Applicant: Zuleyka Marquez; City of Edina  
Consultant: Clark Lohr; Stantec, Inc.  
Project: City of Edina Fire Station #2 Redevelopment  
Location: 4401 West 76<sup>th</sup> Street, Edina, MN  
Applicable Rule(s): 2, 3, 4, and 5  
Reviewer(s): Gabrielle Campagnola and Louise Heffernan; Barr Engineering Co.

### **General Background & Comments**

**Figure 1.** 100-year flood inundation extents at the site (highlighted in blue) and the adjacent 4175 West 76<sup>th</sup> Street property east of site.

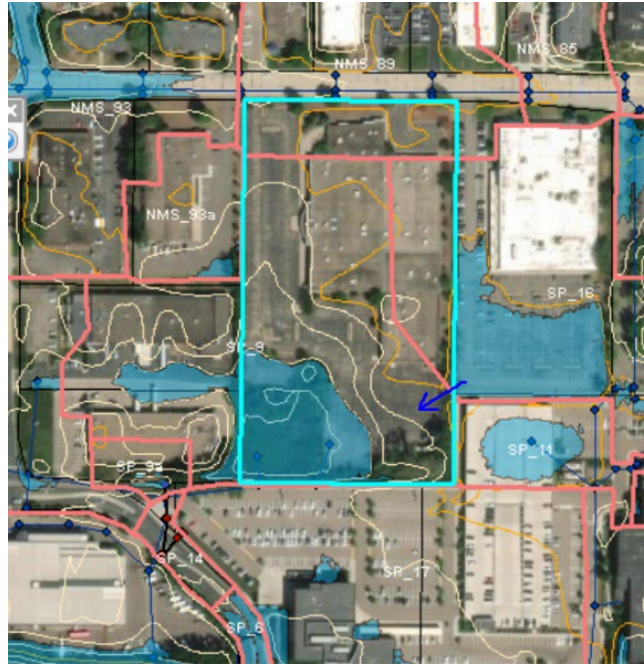
Additionally, under existing conditions, the property east of the site (4175 West 76<sup>th</sup> Street) becomes inundated during the 100-year flood event, and the overflow along the property boundary conveys stormwater runoff toward the project site, as shown by the blue arrow in Figure 1 below. The 100-year flood elevation on the adjacent site is not managed by NMCWD, however, the applicant has submitted information to support compliance with subsection 2.3.3 criteria and the proposed project plans note the existing overflow will be

maintained and identify that the no obstruction or fill is allowed. Grading changes to the overflow and along the eastern border of the property will not result in surface overflow alterations, therefore, the project is not likely to adversely impact the conveyance capacity or direction of flow.

**Figure 2.** Stormwater Management Facility Locations. Areas hatched in blue represent permeable pavement systems and areas hatched in red represent the underground stormwater management facilities.

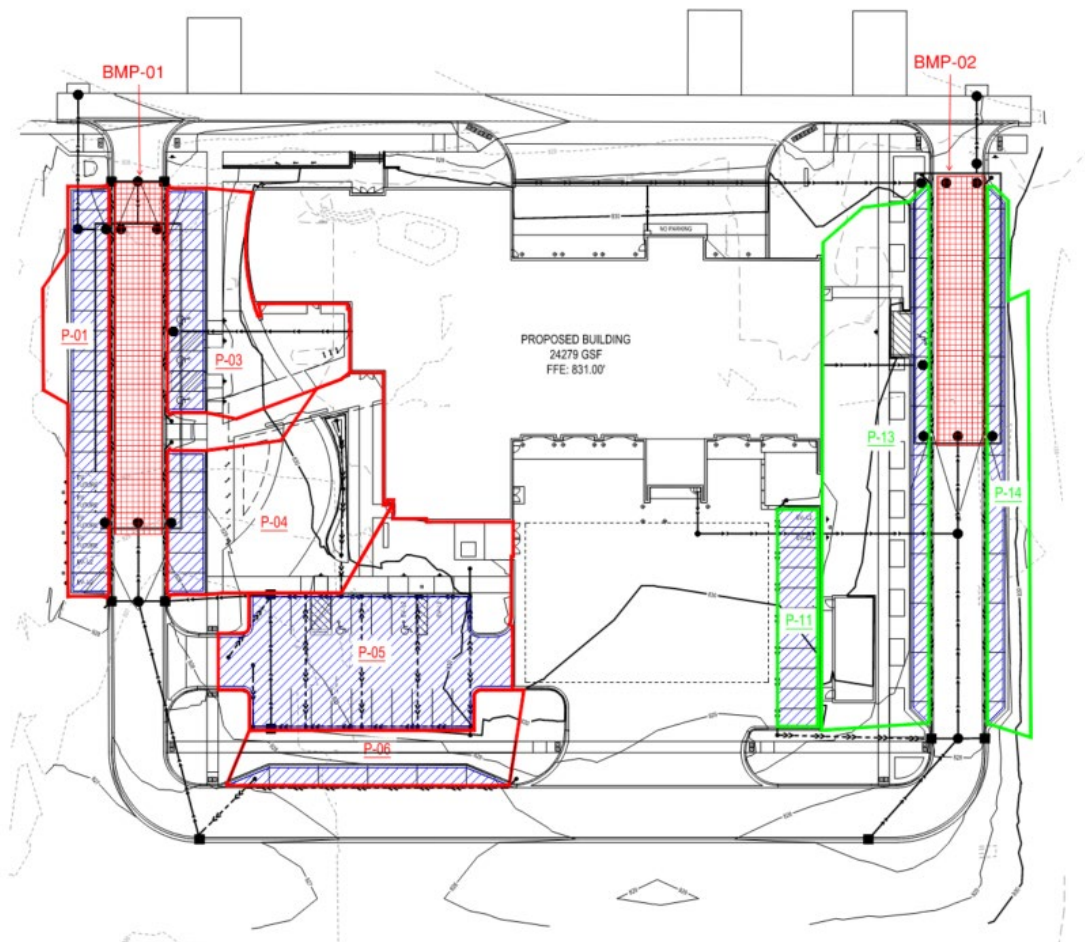
Stormwater management for compliance with Rule 4.3.1 criteria will be provided by ten stormwater management facilities, including two underground stormwater management facilities (UGSWMFs) and eight permeable pavement systems to provide rate control, volume retention and water quality management for the site. The stormwater management facilities' locations, relative to the site, are shown in Figure 2 below. Generally, the majority of stormwater runoff generated by the site is captured by the permeable pavement systems and

routed to the UGSWMFs. The permeable pavement systems collect stormwater runoff from the proposed parking areas, building roof, and adjacent landscaping.

The Minnesota Stormwater Manual states that the drainage area to permeable pavement area ratio should not exceed 2:1. The ratio may be increased to 5:1 if the permeable pavement is receiving roof runoff or has sufficient pre-treatment. The proposed permeable pavement systems were designed to meet the ratio guidance from the Minnesota Stormwater Manual. As mentioned, the UGSWMFs receive runoff from the permeable pavement systems, however, each UGSWMF receives runoff from parking lot areas that are not directed to the permeable pavement systems.

1 CROSS-SECTION OF PERMEABLE PAVEMENT AND STORMTRAP SYSTEMS  
C-805 NOT TO SCALE

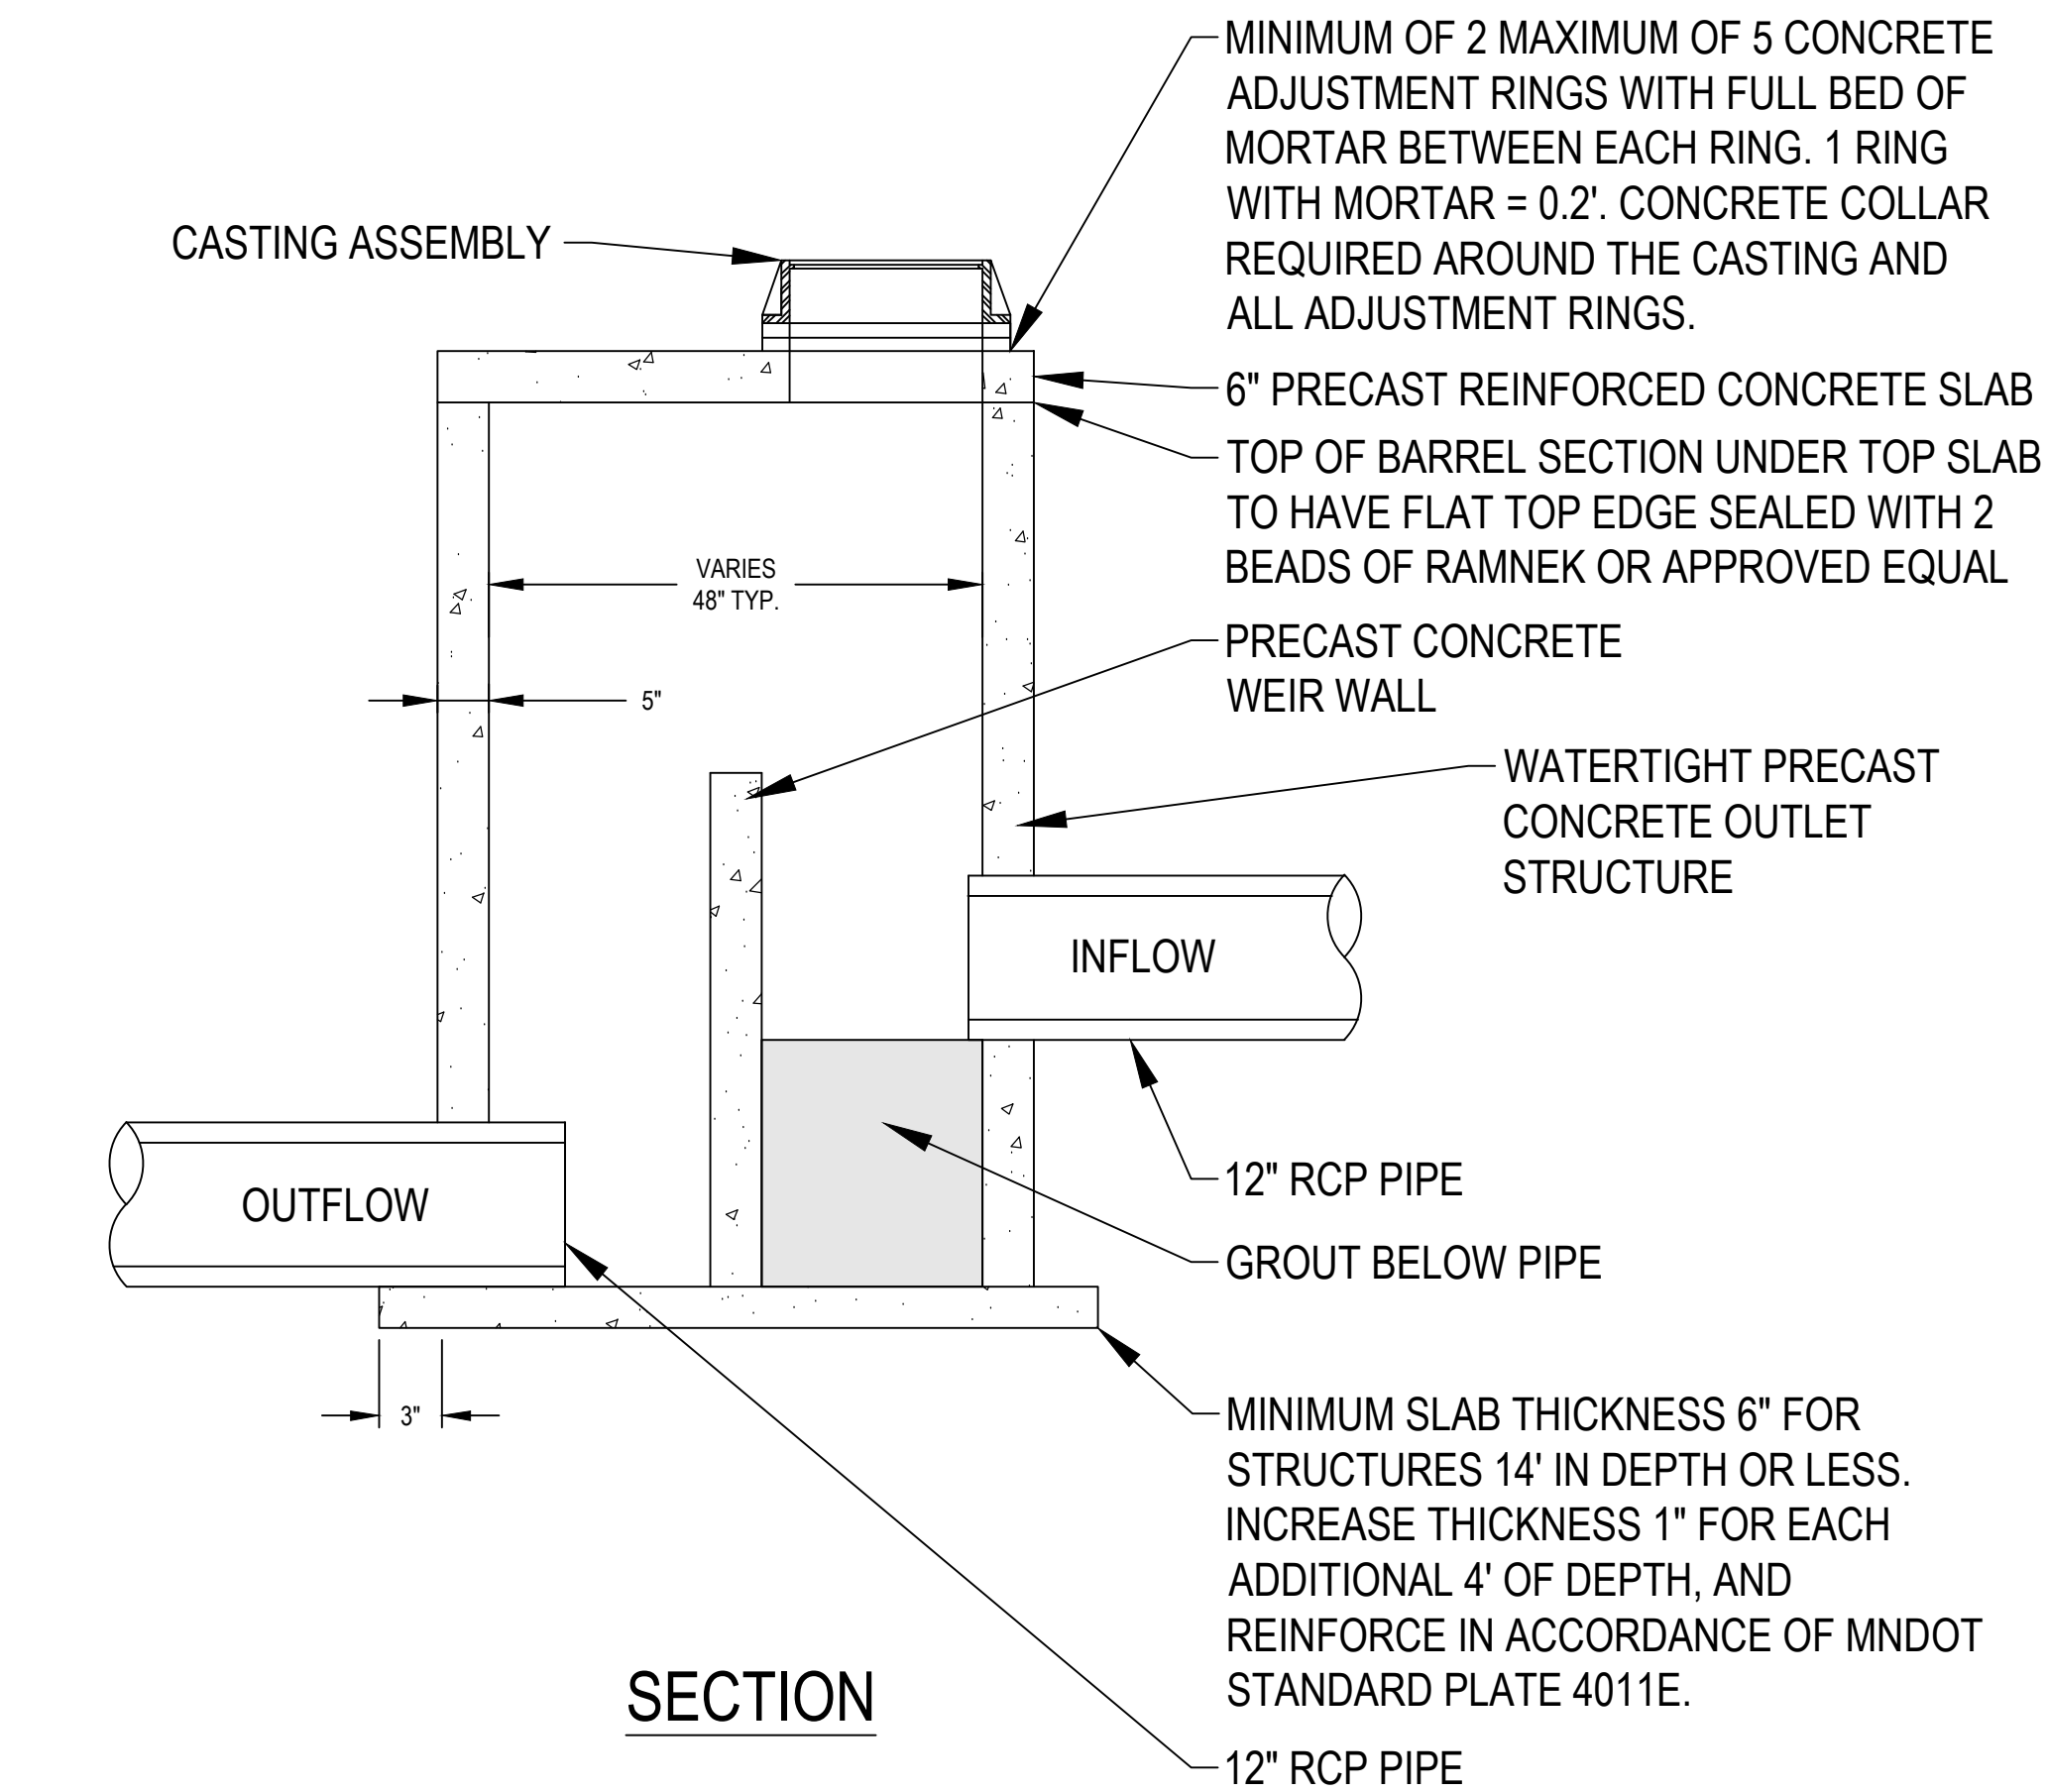
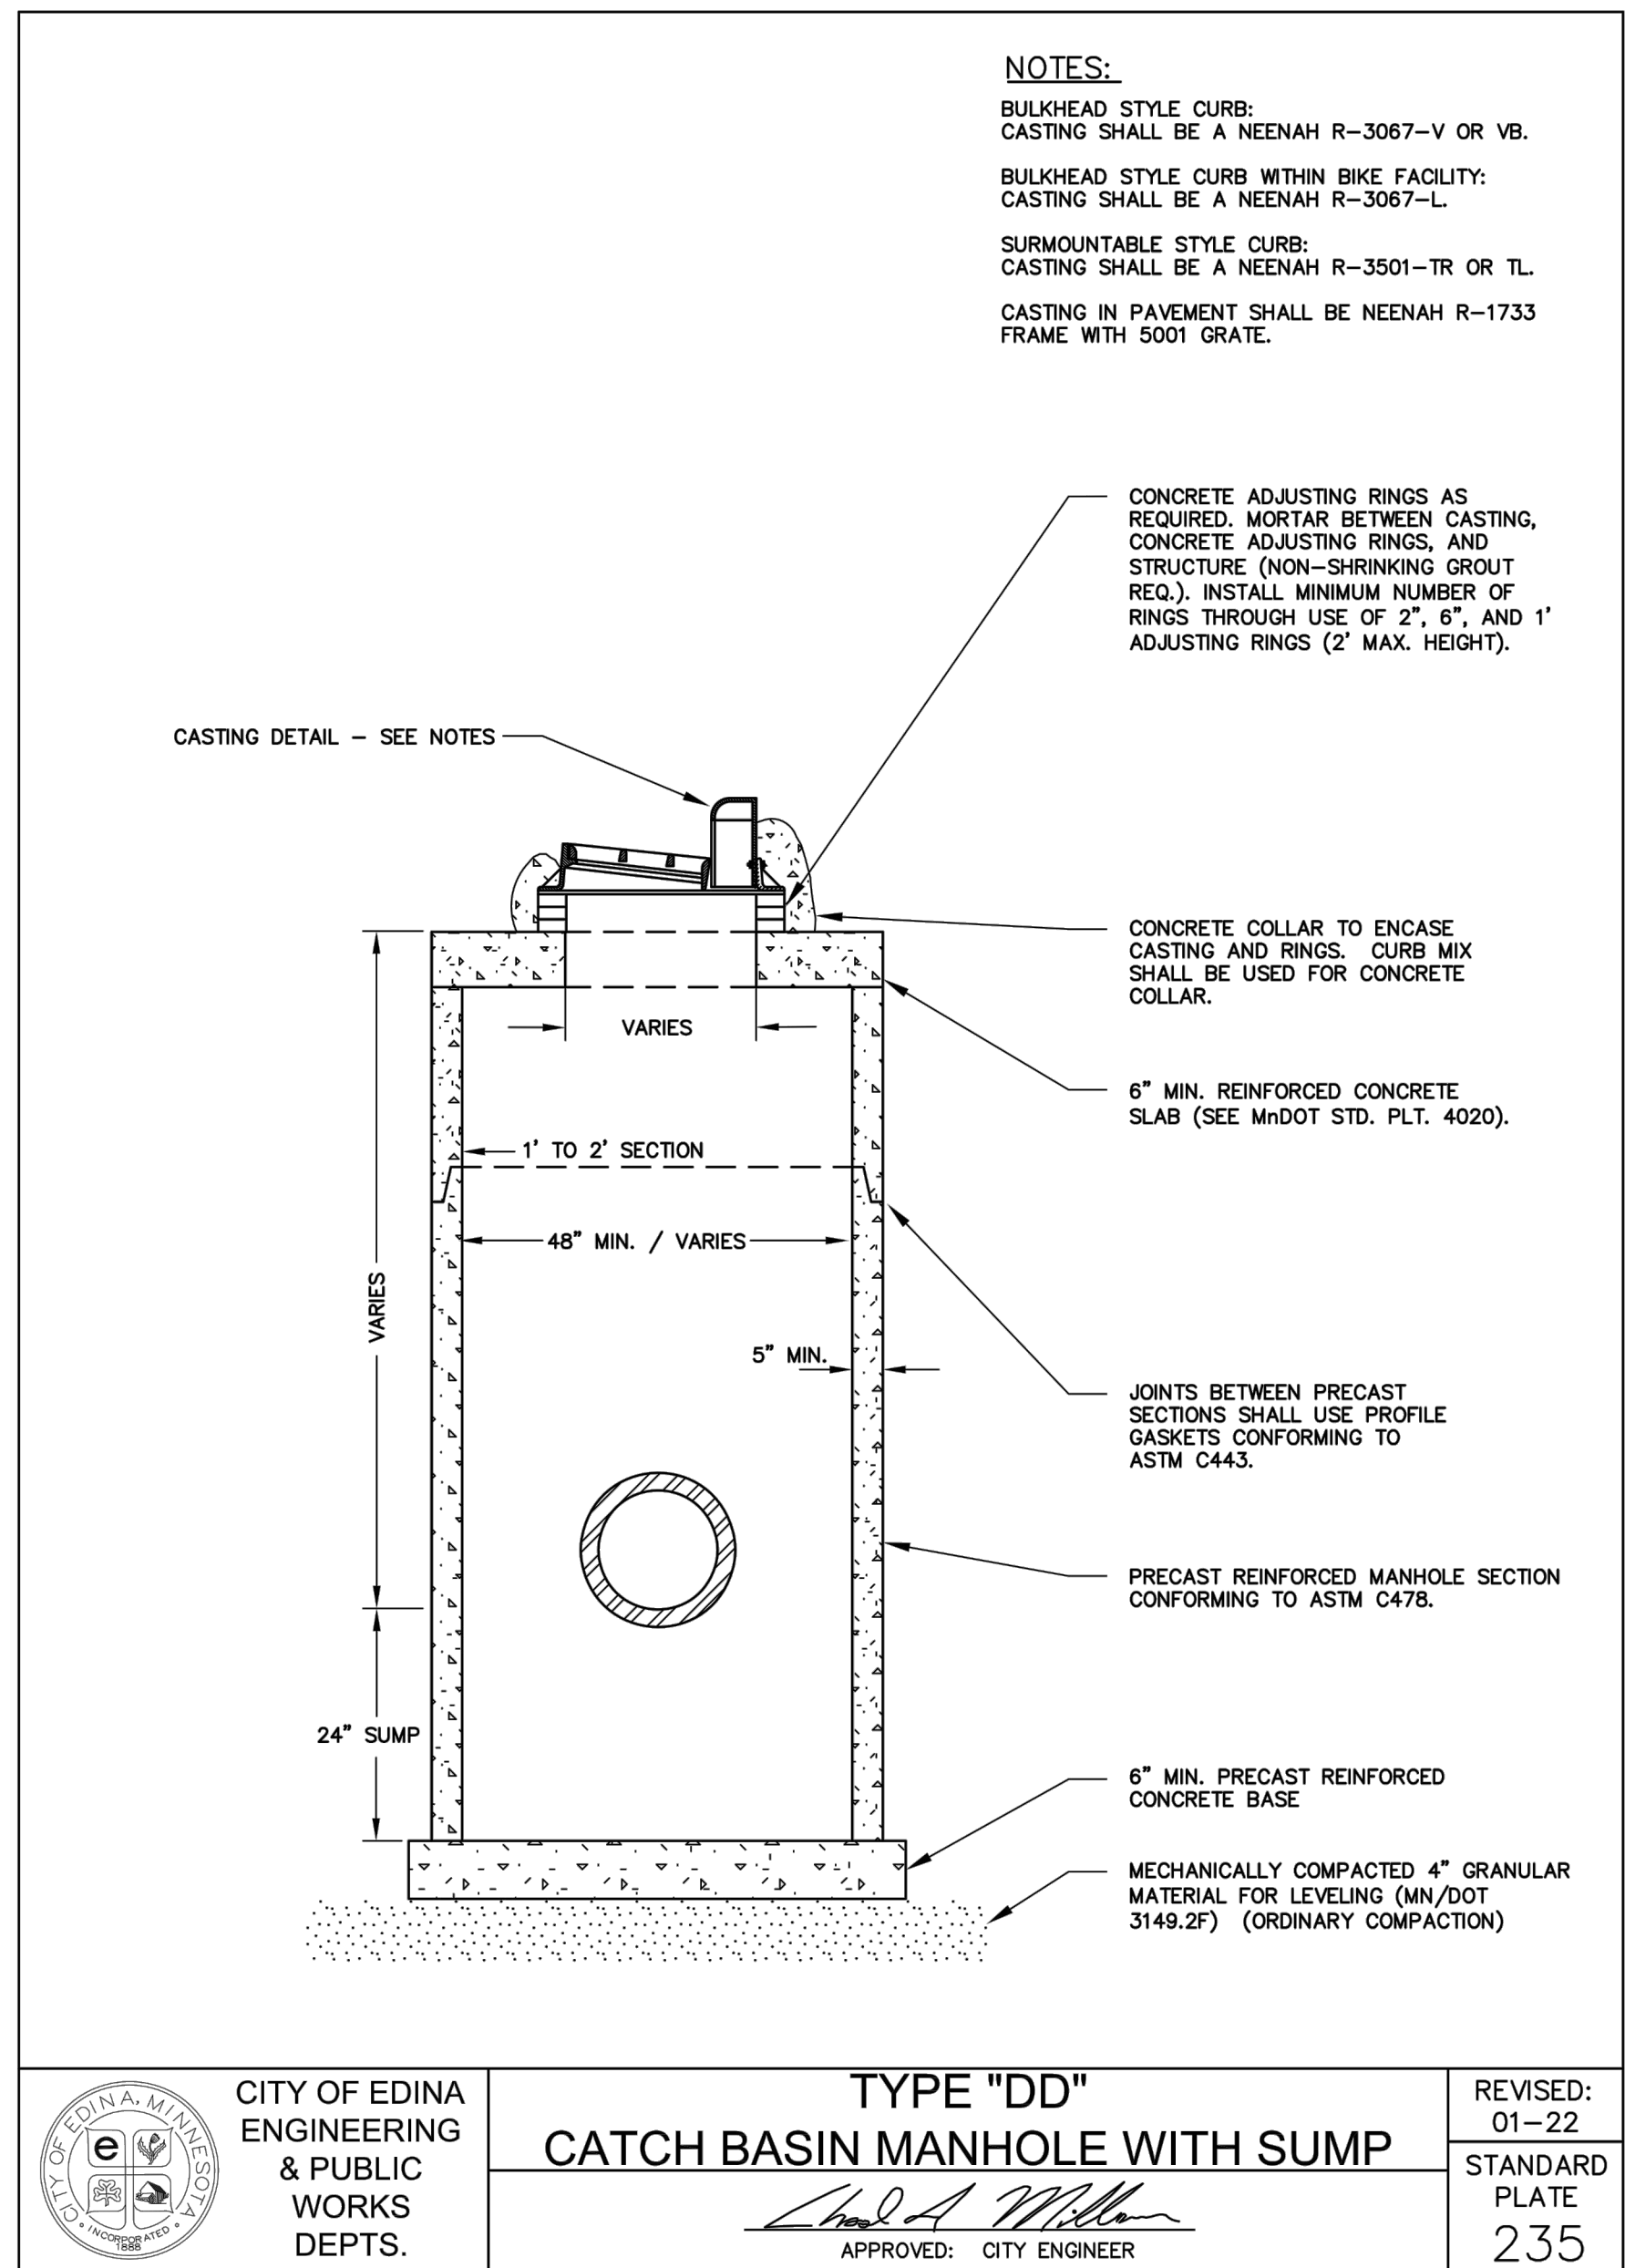
The system invert elevation of BMP-2 identified on the utility plan does not appear to match the invert elevation identified on the utility plan table, HydroCAD modeling, and system detail. The utility plan callout for BMP-2 must be revised for consistency.
